Appl. No.10/642,716

Amendment August 13, 2004

Reply to Office action of May 13, 2004

Fig. 3

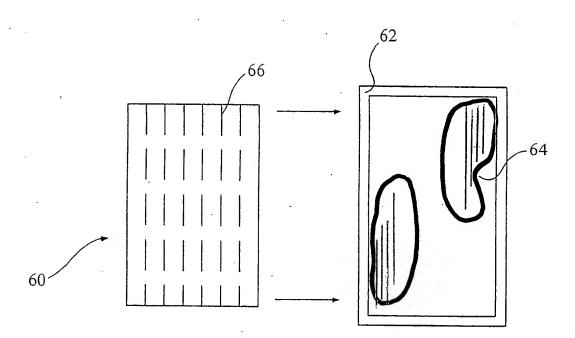
The Examiner has objected to Fig. 3 by asserting that Fig. 3 uses the reference numeral 64 to denote the frame material. However, insofar as illustrated in Fig. 3 there is no discernible structure which could represent the frame material as denoted by the reference numeral 64.

In response to this objection, the applicant respectfully requests to amend Fig. 3 to discern the frame material 64 by placing shading lines on the frame material, which, as illustrated, is

within the panel frame 62. This amendment finds support at page 6, lines 19-23, where it teaches, "The panel frame 62 preferably includes a frame material 64 which attracts and holds the removable decorative panel 60 to the panel frame 62." Thus, no new matter has been added.

The applicant respectfully submits that the above-stated change to Fig. 3 clearly discerns the frame material 64 from the panel frame 62. However, if the Examiner would prefer different language for the term "frame material", the applicant would consider such an amendment.

Fig. 1

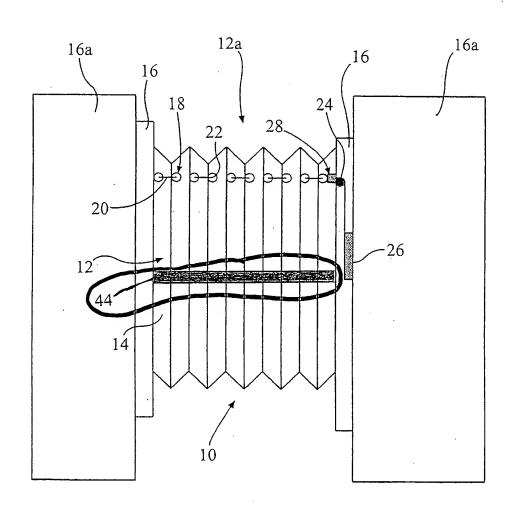
Claim 3 is indefinite for it sets forth the embodiment of the folding panel assembly as drawn to figure 1 as having a locking bar, wherein, only the embodiment of the folding panel assembly as drawn to figure 2 is disclosed as comprising the locking bar.

In response to the Examiner's rejection of claim 3, the applicant respectfully requests to amend Fig. 1 by adding a locking bar 44 thereto, which finds support in the originally filed Abstract of U.S. Patent Application Serial No. 09/524,339, wherein it teaches that, "In another

embodiment, the security system includes a locking bar that allows the panels to stay in the expanded position." It is the applicant's position that the embodiment being referred to in this portion of the originally filed Abstract comprises a single door embodiment, since the very next sentence in the originally filed Abstract teaches that another embodiment is that of the two opposing panel doors, where it states, "In addition, two opposing panel doors can be mounted to a wall frame using spring-loaded hinges to allow the panel doors to swing open and closed."
